PLANNING REPORT

Planning and Zoning Commission

All In Dublin 25-115 FDP

Address	PID: 273-013221
Location	East side of Dublin Center Drive between W. Dublin Granville Road and Bunker Drive.
Proposal	Construction of a four-story, 75-unit multi-family building and associated site improvements on a 1.59-acre site
Request	Review and approval of a Final Development Plan under the provisions of Zoning Code Section 153.066.
Zoning	BSD-SCN, Bridge Street District – Sawmill Center Neighborhood
Planning Recommendation	Approval of a Parking Plan Approval of 4 Administrative Departures Approval of 15 Waivers Approval of the Final Development Plan with Conditions
Next Steps	Upon review and approval of the Final Development Plan, the applicant may be eligible to apply for site and building permits
Applicant	Mark Dunham, Executive Director, All Inclusive Living
Case Manager	Bassem Bitar, AICP, Deputy Director of Planning (614) 410-4635 bbitar@dublin.oh.us

Pocket Park A (Northwest Corner of Site)

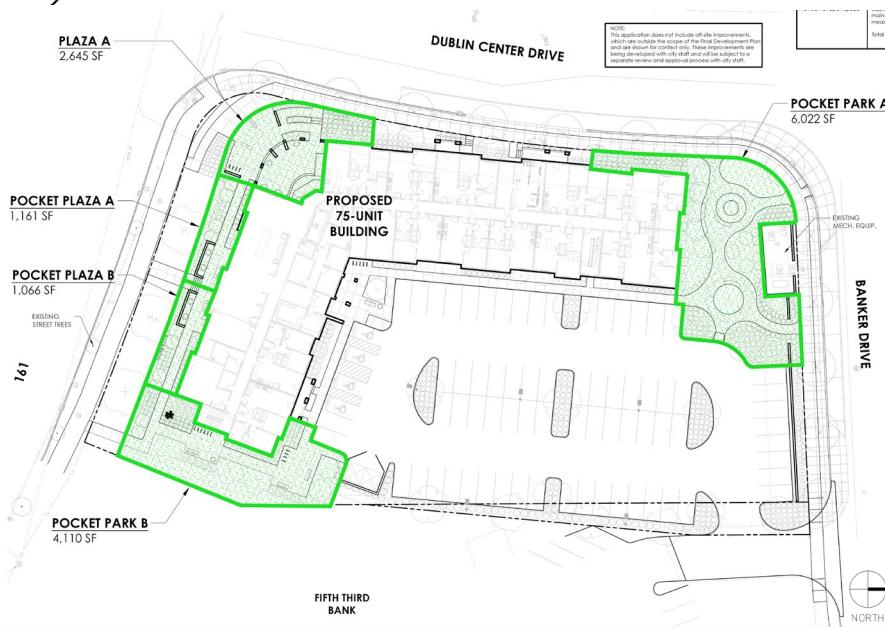
The applicant has significantly increased the usable open space by adding a brick enclosure around the existing mechanical equipment and relocating the proposed generator into that enclosure. As now proposed, the open space would include multiple seating areas, ADA access

to the parking lot and adjacent public sidewalks, a water feature, a public art opportunity, a pollinator garden, and a sensory garden. The changes allow for a variety of public open space experiences while minimizing the impacts of the mechanical equipment. The pocket park extends south along a portion of the building's west façade to help provide an edge between the public and private realm in an area where the required 2.5' differentiation between the sidewalk and finished floor elevation cannot be met (see Building Type and Architecture section below). However, as currently proposed, this area is disconnected from the larger open space. The plating plan and plant selections for this area should be modified to create a defined edge along the walkway just north of the building consistent with the pocket park's other edges. This is included as a recommended condition of approval. All Pocket Park standards are met.

- 4) The planting plan and plant selection for the southern strip of Pocket Park A shall be modified to create a defined edge along the walkway north of the building, consistent with the pocket park's other edges.
